**ADDENDUM No. 1**

**Request for Proposal CS-20-23  
SHELL-GLEN RESCUE TRUCK**

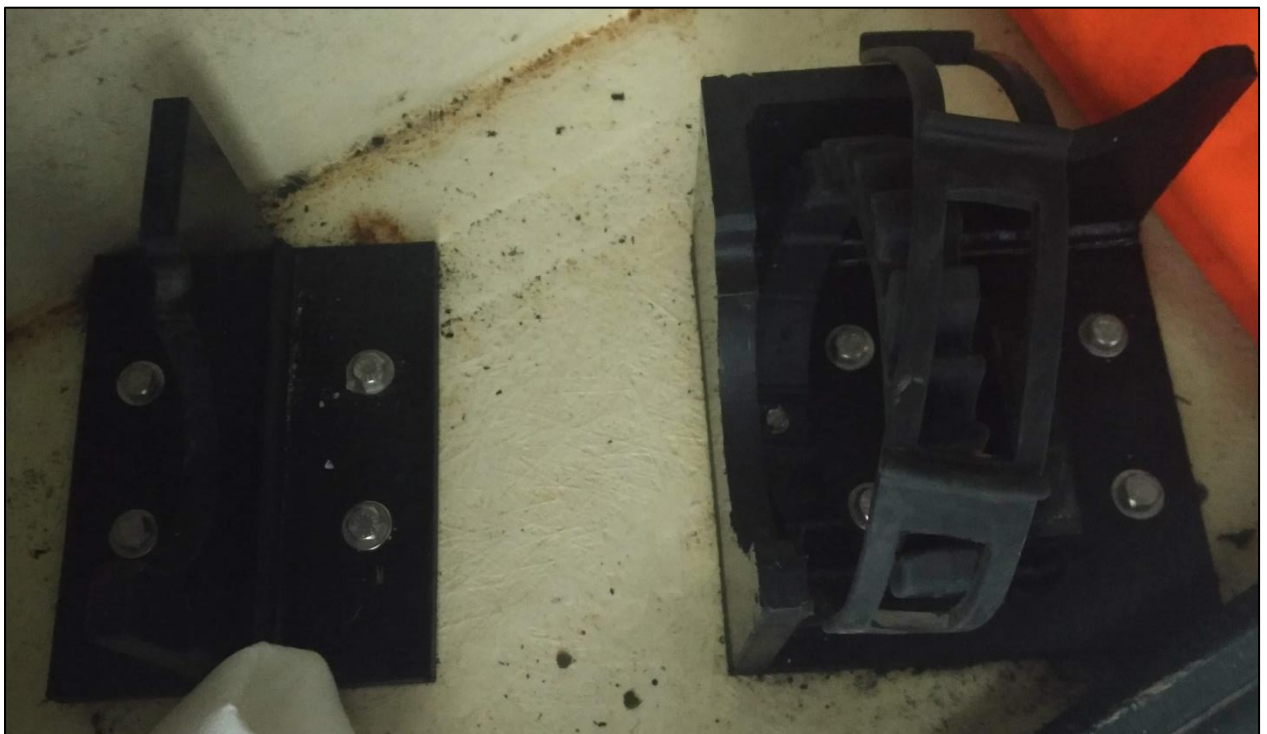
QUESTION 7: Re Item #4 – What make, and model are the mounting brackets?

**ANSWER 7: Mounting brackets are for Holmetro 3000 series tools. PAC compatible plastic mounting brackets. See photos below.**
